Model: General RTB	Date: 4-Feb-03	No.: RGene013b
--------------------	----------------	----------------

Subject: Service remarks at installation		Prepared by: T. Itoh	
From: Technical Service Sec. Service Planning Dept.			
Classification:	<input type="checkbox"/> Troubleshooting <input type="checkbox"/> Part information <input type="checkbox"/> Action required		
	<input type="checkbox"/> Mechanical <input type="checkbox"/> Electrical <input type="checkbox"/> Service manual revision		
	<input type="checkbox"/> Paper path <input type="checkbox"/> Transmit/receive <input type="checkbox"/> Retrofit information		
	<input checked="" type="checkbox"/> Other (Specification change)

Model: Model AR-P1		Date: 29-Jun-05	No.: RG081007
Subject: Vertical thin line problem		Prepared by: K. Moriizumi	
From: 1st Tech. Support Sec. Service Support Dept.			
Classification:	<input checked="" type="checkbox"/> Troubleshooting	<input type="checkbox"/> Part information	<input type="checkbox"/> Action required
	<input type="checkbox"/> Mechanical	<input type="checkbox"/> Electrical	<input type="checkbox"/> Service manual revision
	<input type="checkbox"/> Paper path	<input type="checkbox"/> Transmit/rece

Case 2

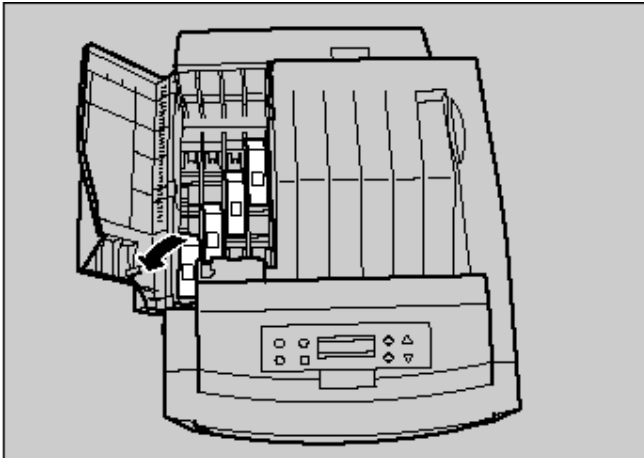
The toner is not supplied. The protection sheets for the toner supply holes must be removed at installation, as shown in the following drawing. If the protection sheet is not removed and the toner bottle is installed, the toner cannot be supplied. The low toner condition will damage the PCU surface.

Replace the PCU and add toner.

The diagram on the right shows the inside of the PCU.

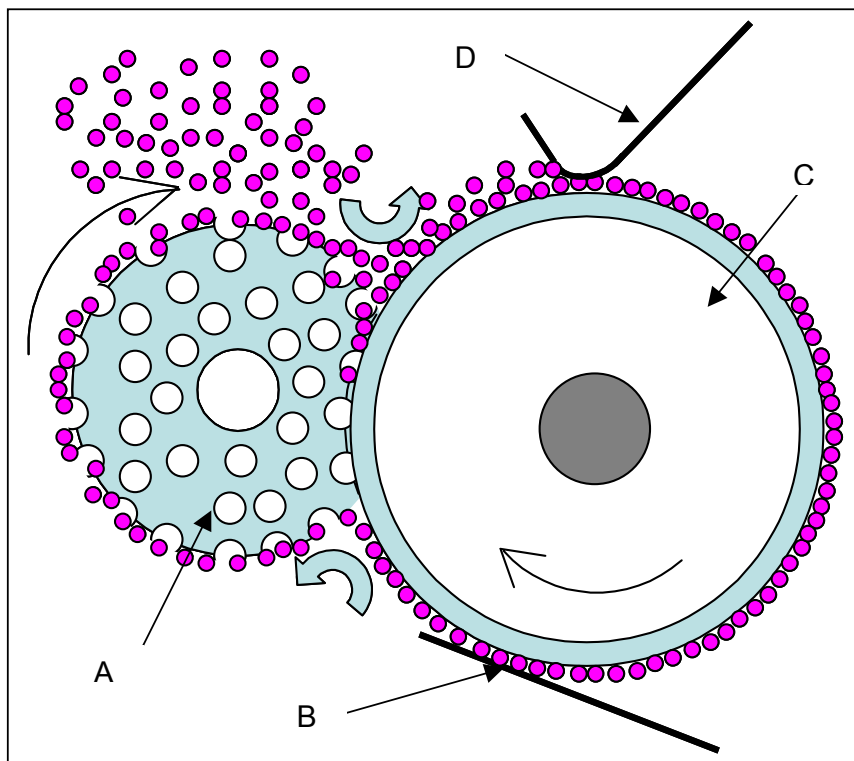
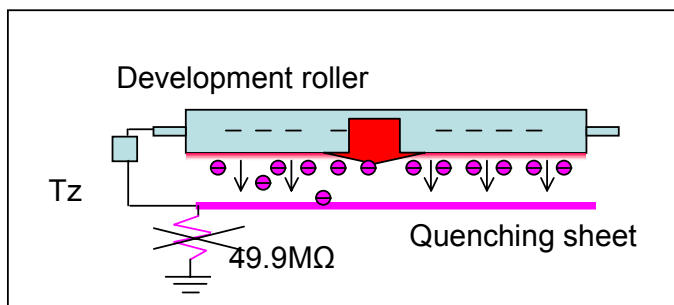
There is a potential difference of about 63V between the development roller and the quenching sheet because of a zener diode (Tz).

The toner will be gathered on the surface of the quenching sheet because of the potential difference. Then, the toner will be fixed on the quenching sheet.

This toner scratches the development roller surface.

The resistor that connects the quenching sheet to the ground will be removed. The electric level of the quenching sheet will be same as the development roller in order to prevent toner from gathering on the sheet.

This modification was available from the September 2004 production.
